Staff Report City of Richmond, Virginia

Commission of Architectural Review

8. COA-158301-2024	Final Review Meeting Date: 12/17/2024	
Applicant/Petitioner	Jason lannotti	
Project Description	Alter a rear parking lot to include new hardscaping, landscaping, and site features.	
Project Location	616 2419 • 623	
Address: 2516 East Leigh Street	2405 (6)8 (6)9 (250) (7) (6)9 (6)9 (7) (5)13/17 (7) (7) (7) (7) (7) (7) (7) (7) (7) (7	
Historic District: Church Hill North	616 (72524) 607 (605) 607 (605)	
High-Level Details:	517 1205 120 120 120 120 120 120 120 120 120 120	
The primary structure is a 64 unit apartment building for seniors built ca 1914. The applicant proposes to alter the existing rear parking lot by installing new paving, curbing, sidewalks, fencing, landscaping, and site features such as a new dumpster enclosure and a new picnic area.	5618 Church Hill North 617 620 618 620 619 610 620 610 620 611 620 620 620	
Staff Recommendation	Approval, with Conditions	
Staff Contact	Alex Dandridge, alex.dandridge@rva.gov, (804) 646-6569

Figure 2: Rear parking lot, facing North.

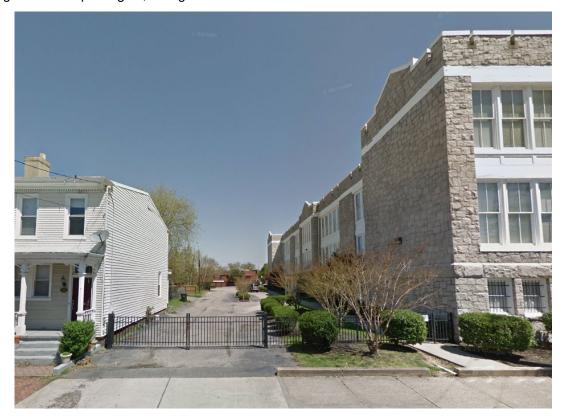
As part of the redesign, the applicant plans to relocate the garbage disposal area from the northwest corner of the parking lot to the southeast corner along the E. Leigh Street side. The new disposal area will be screened with a dumpster enclosure, enhancing its visual appeal and functionality. The new enclosure will be brick with gray-colored metal gates. The previously existing garbage disposal area will be repurposed into a picnic area.

Additionally, the applicant proposes removing the existing landscaped island to create a new accessible entrance at the rear of the building. This redesign includes additional landscaping to visually break up the parking lot and improve accessibility to the building's rear entrance.

Applicant proposes to retain two of the more mature trees that are closest to the buildings rear entrance. Remaining Crepe Myrtles and mulch landscaping cutouts to be removed.

Staff recommends approval provided all appropriate permitting and zoning requirements are fulfilled.
